Evaluation of three as-built aLigo optical levers at LHO: PR3, HAM2, ITMY

Cheryl Vorvick
Optical Lever Acceptance Review
LHO
6/6/2013
T1300651-v1

PR3 Optical Lever

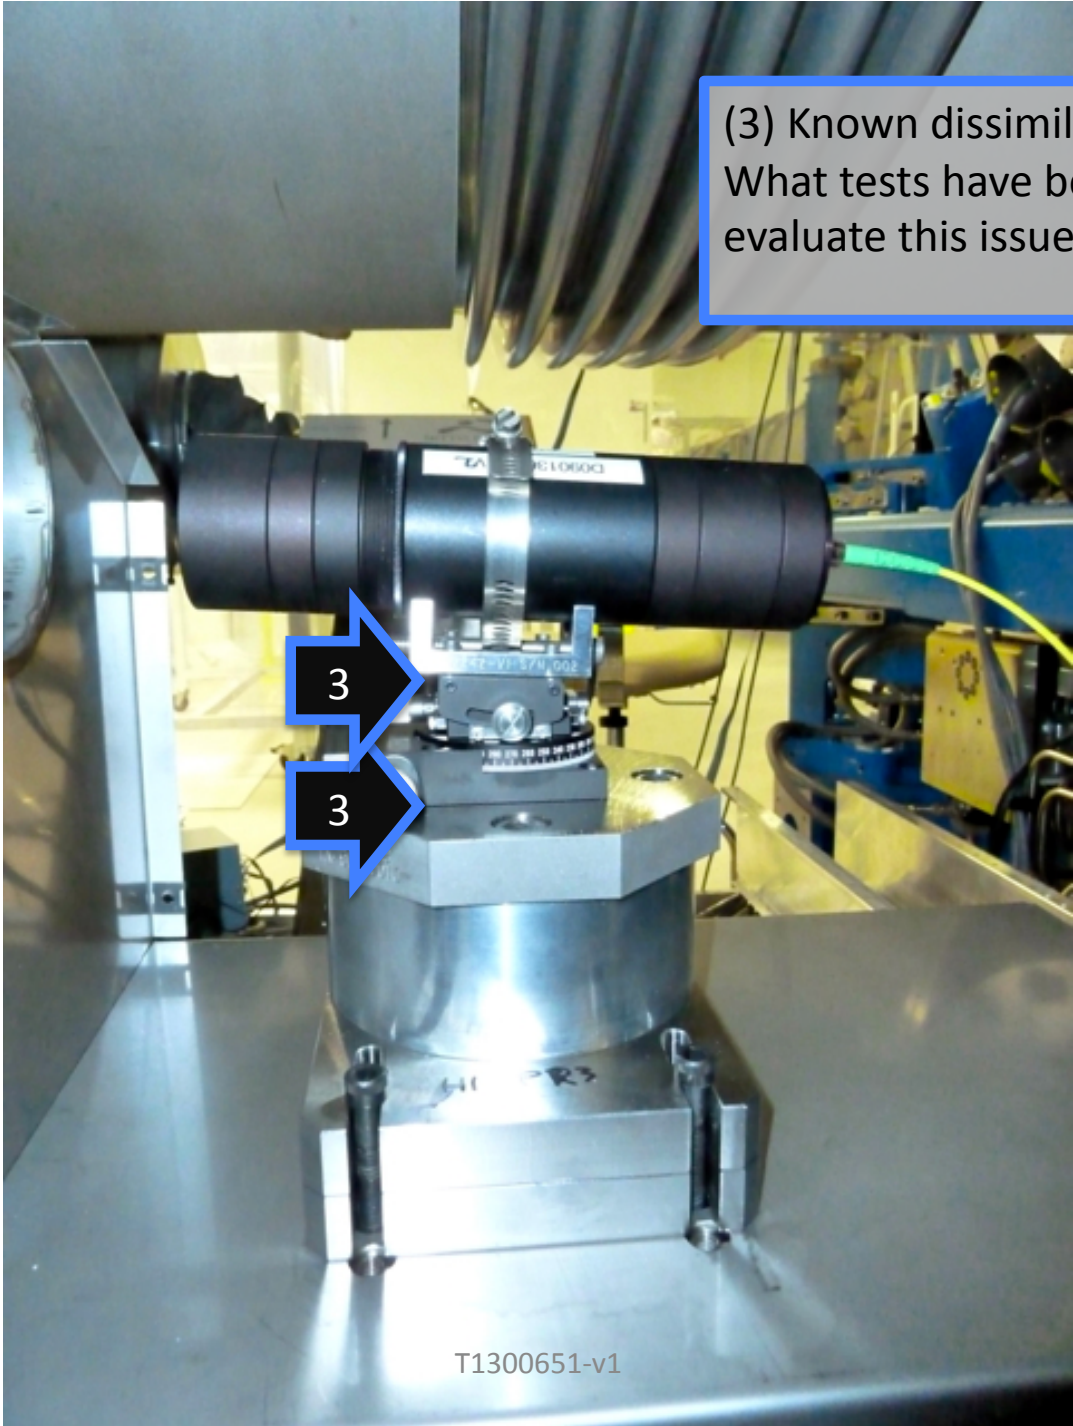
(1) Even if strain relief is added to this fiber, the potential to change the pointing every time the housing is removed is great!

(2) Additionally, the connector itself is likely sensitive to temperature changes, which will also change the pointing.

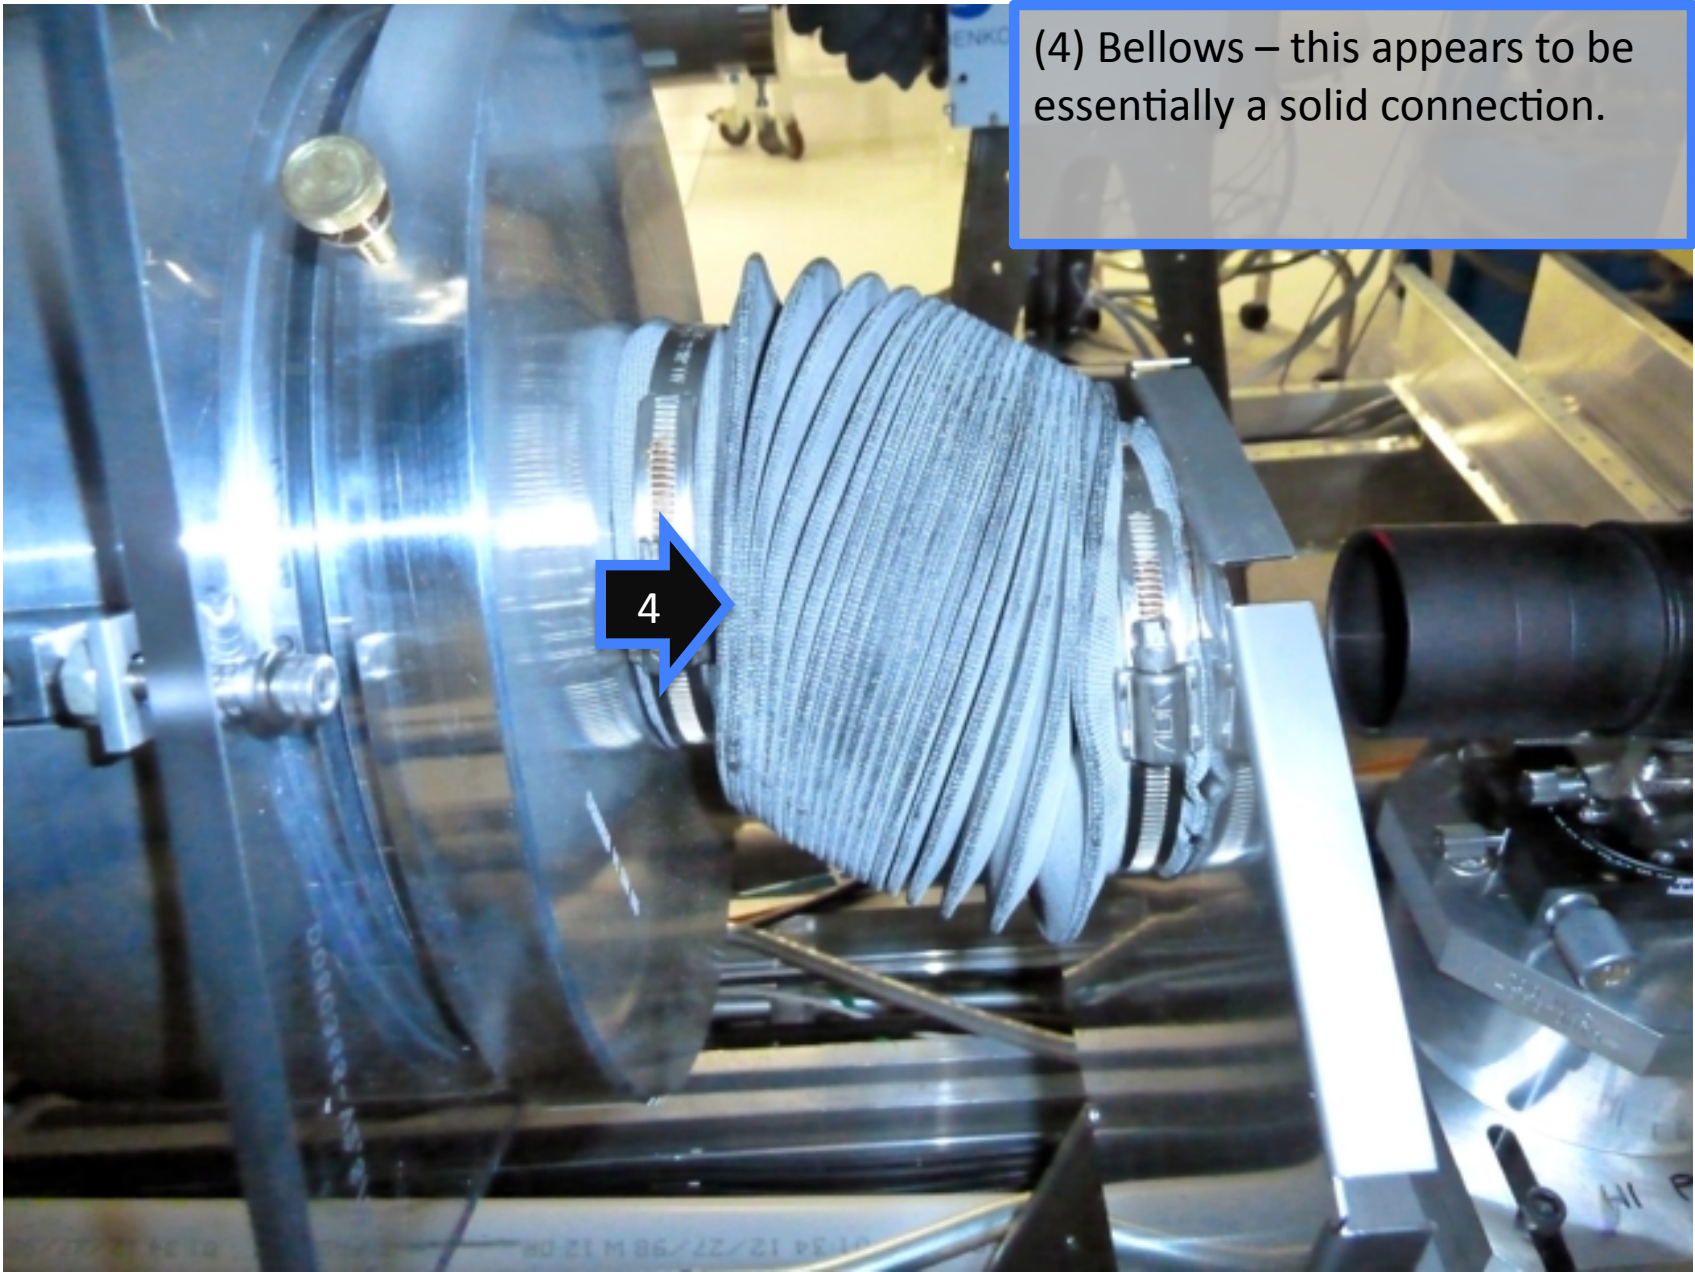
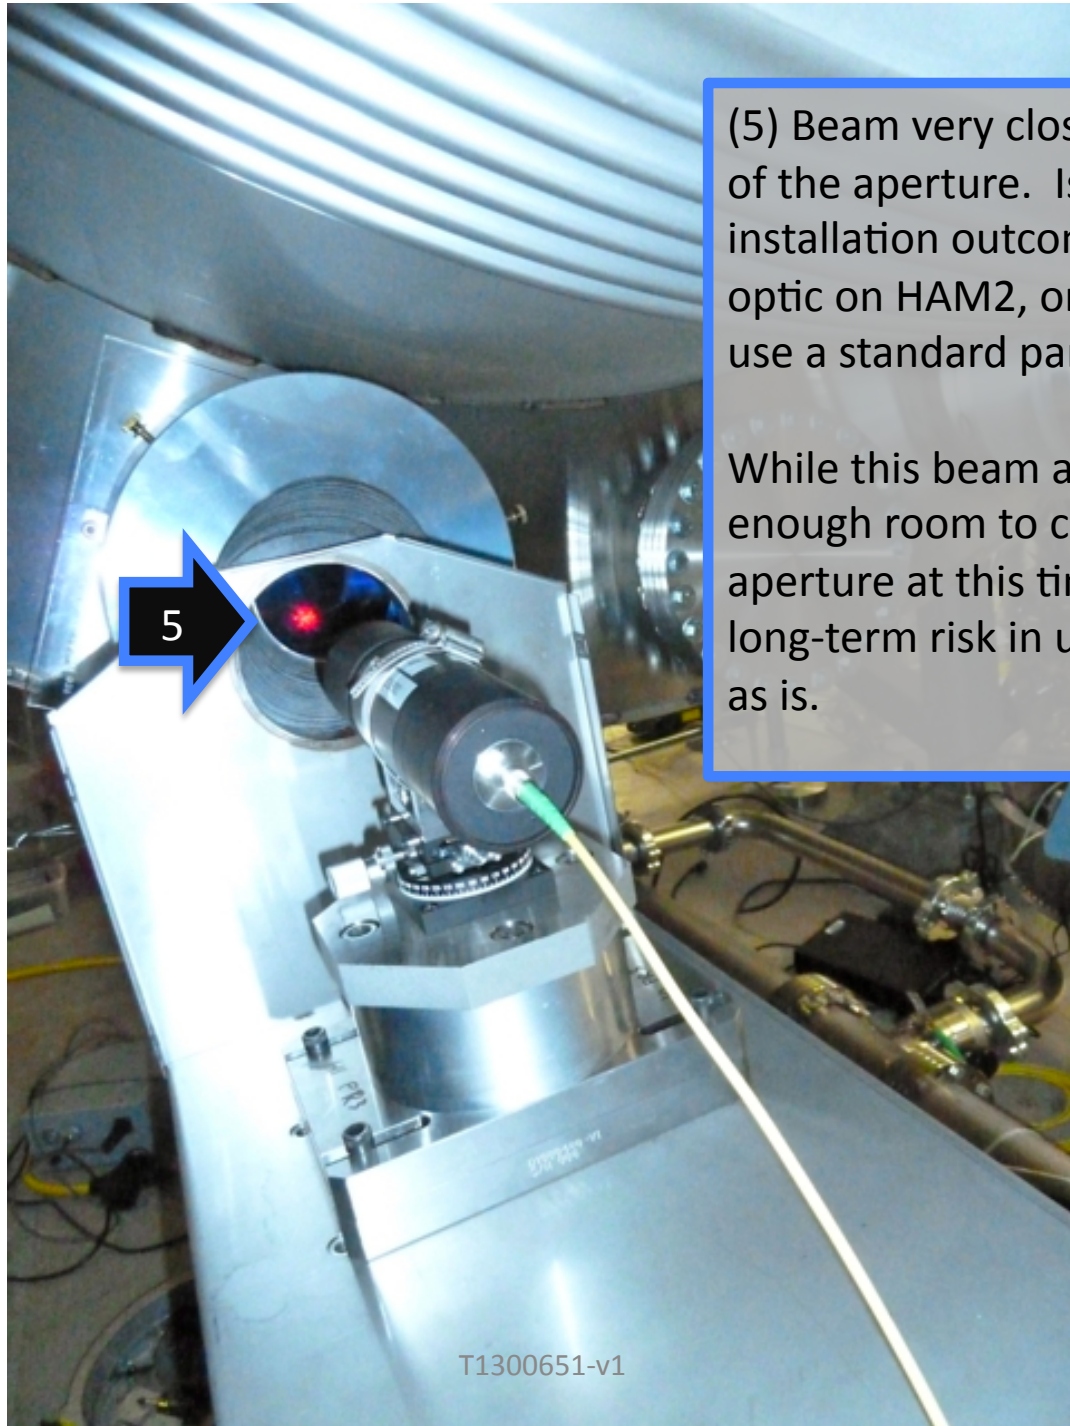
(3) Known dissimilar metal issue?
What tests have been done to
evaluate this issue?

(4) Bellows – this appears to be essentially a solid connection.

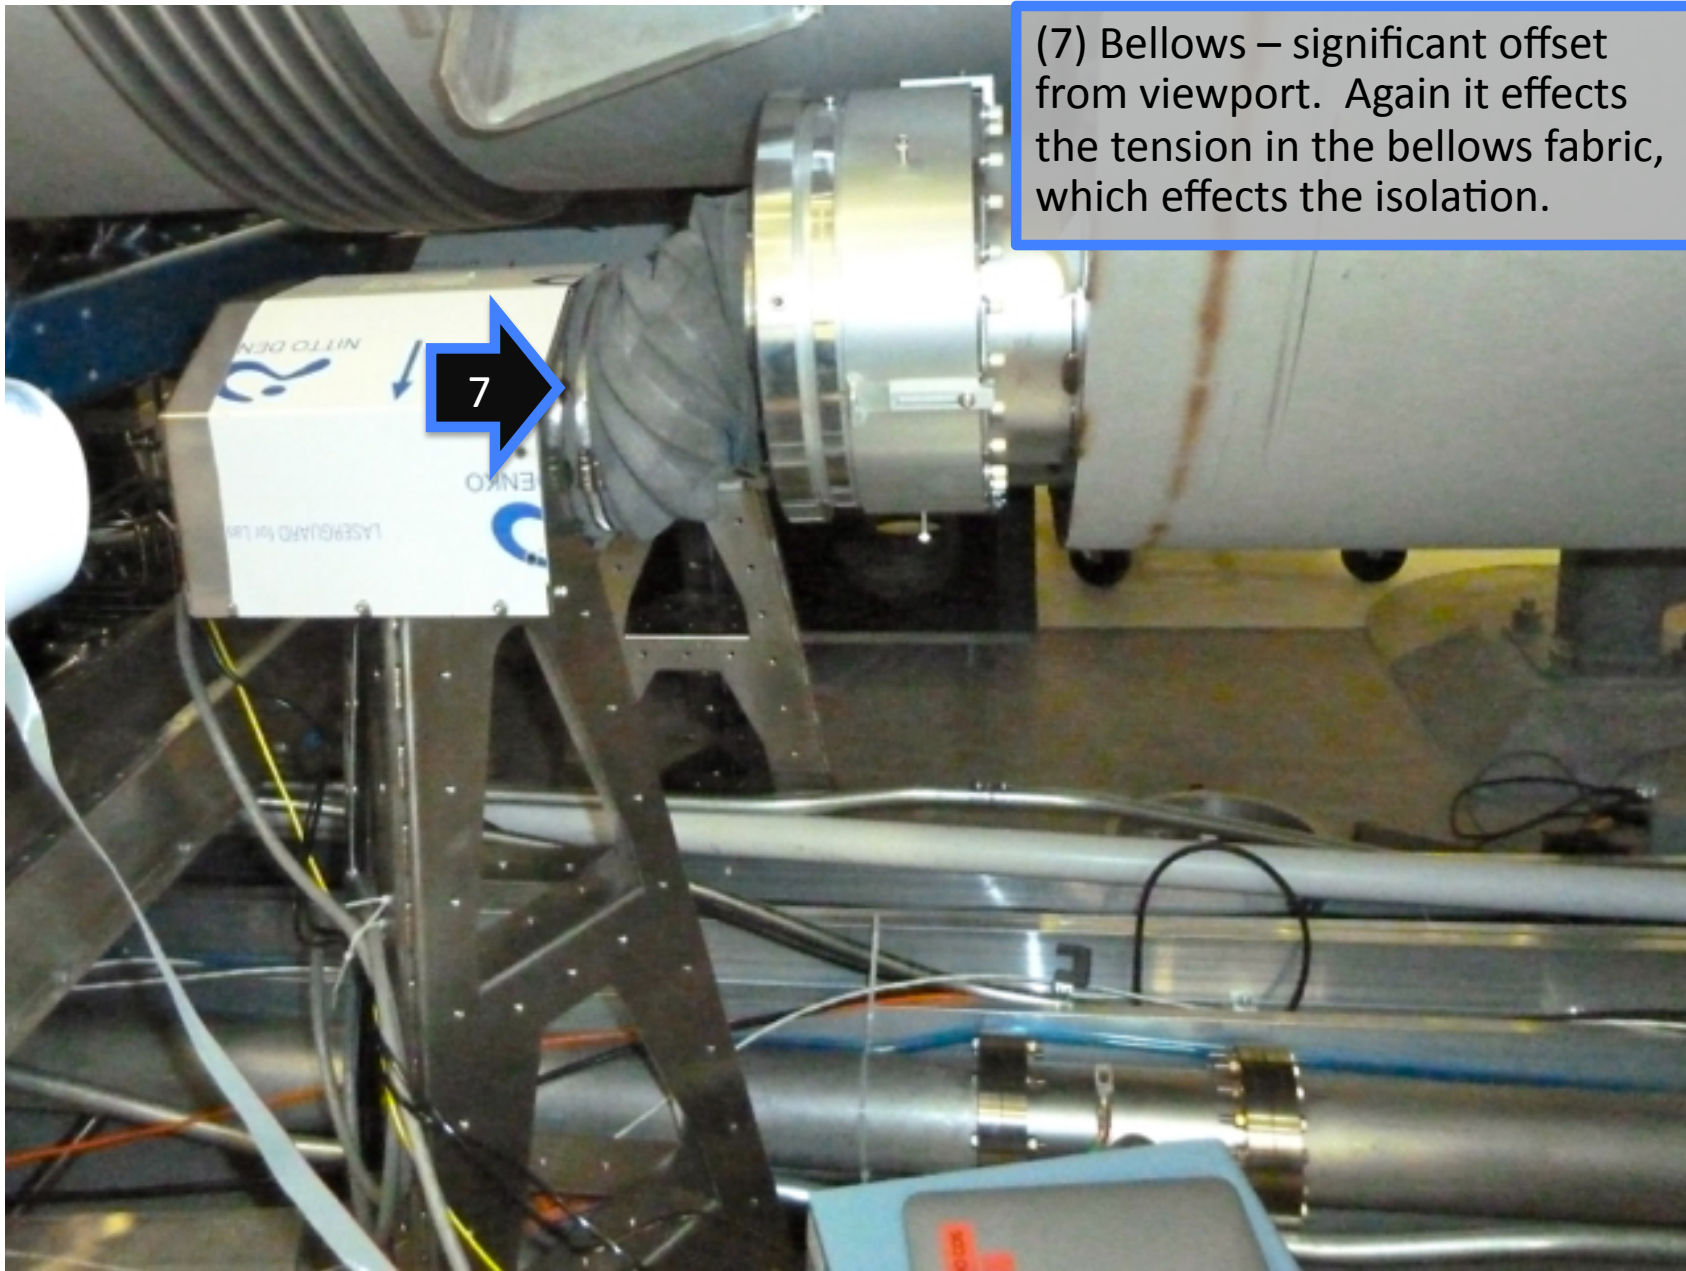
(5) Beam very close to the edge of the aperture. Is this installation outcome due to the optic on HAM2, or some need to use a standard part?

While this beam appears to have enough room to clear the aperture at this time, there is a long-term risk in using the setup as is.

(6) One-piece housing may seem like a good idea, but increases the chance of impact as it's installed and removed, and exposes every part inside the housing to contamination and impact risks while the housing is not installed!

There is a time that happens after installation, and before a science run, where access to the hardware is necessary. **Housings need to protect hardware AND allow access while minimizing risk.**

HAM2 Optical Lever

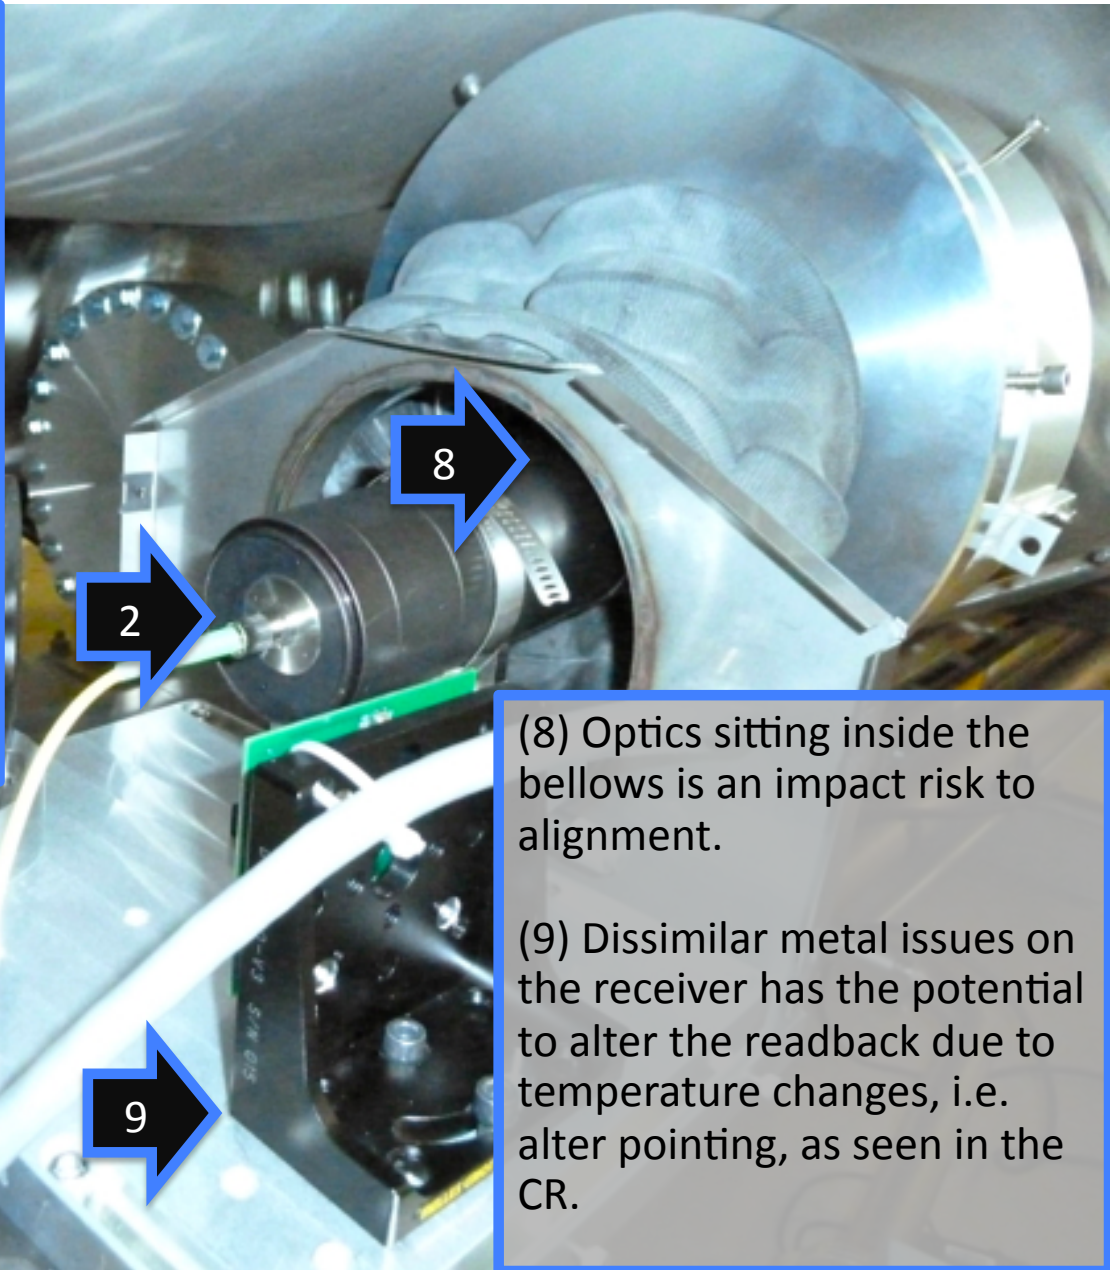
(7) Bellows – significant offset from viewport. Again it effects the tension in the bellows fabric, which effects the isolation.

(1) This fiber, even if strain relief is added, will potentially cause alignment changes due to the removal and installation of the housing.

(2) Fiber attachment point sensitivity to temperature - effect on pointing?

Removing the housing by definition will change the temperature.

(8) Optics sitting inside the bellows is an impact risk to alignment.

(9) Dissimilar metal issues on the receiver has the potential to alter the readback due to temperature changes, i.e. alter pointing, as seen in the CR.

ITMY Optical Lever

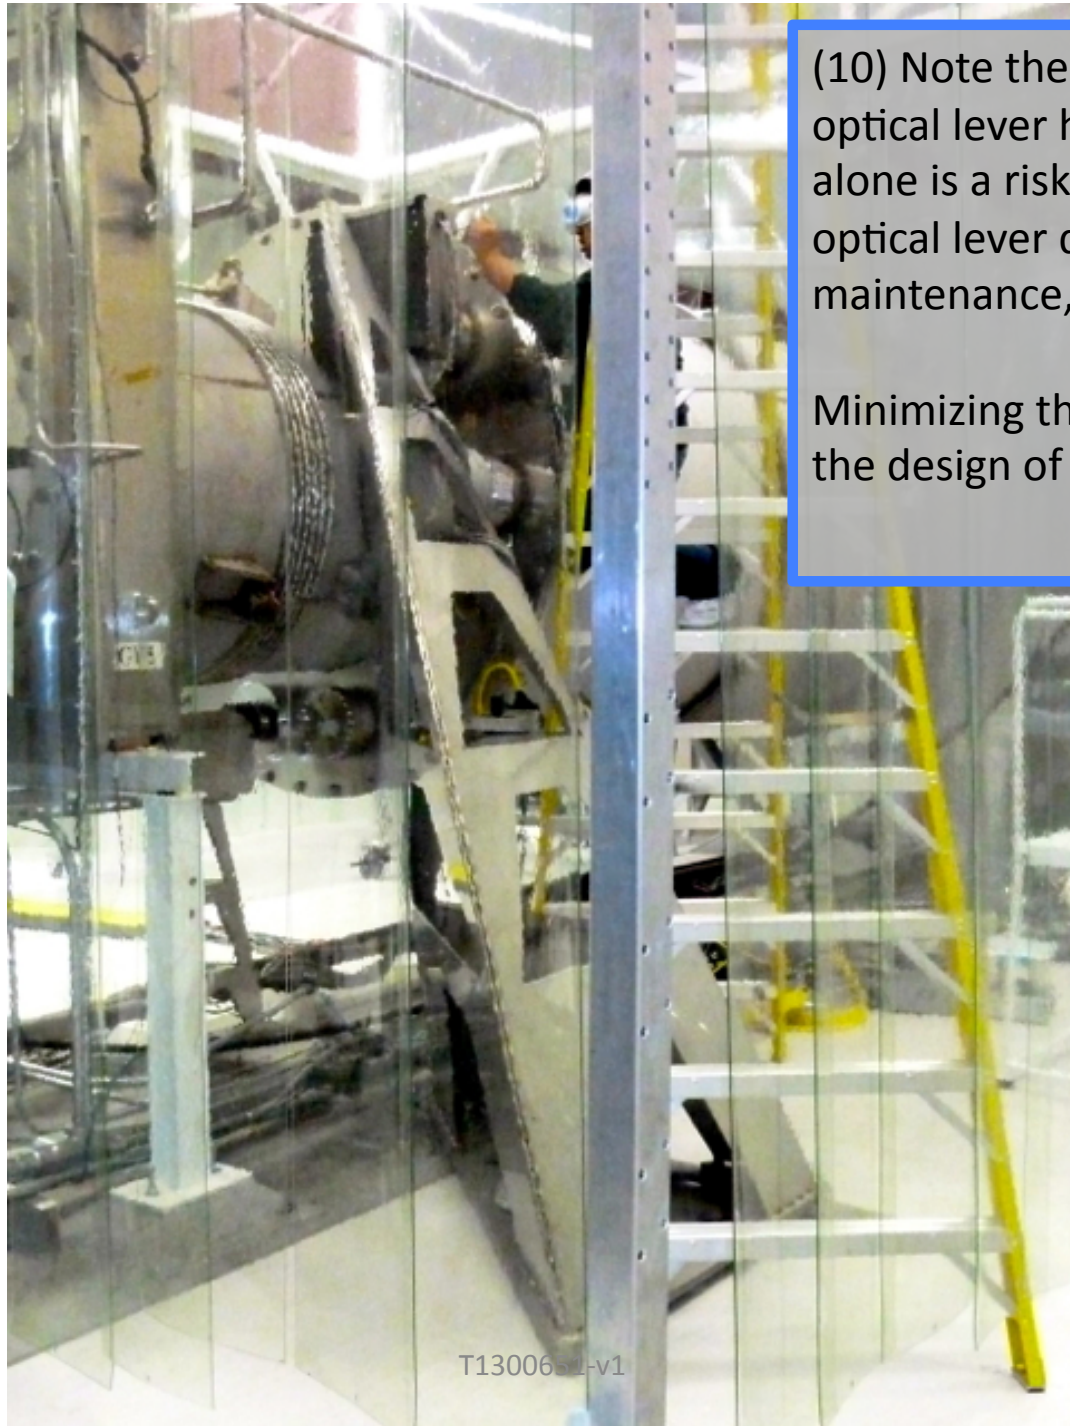
(10) Note the height of this optical lever hardware. Height alone is a risk factor for this optical lever during installation, maintenance, and operation.

Minimizing this risk should drive the design of the housing.
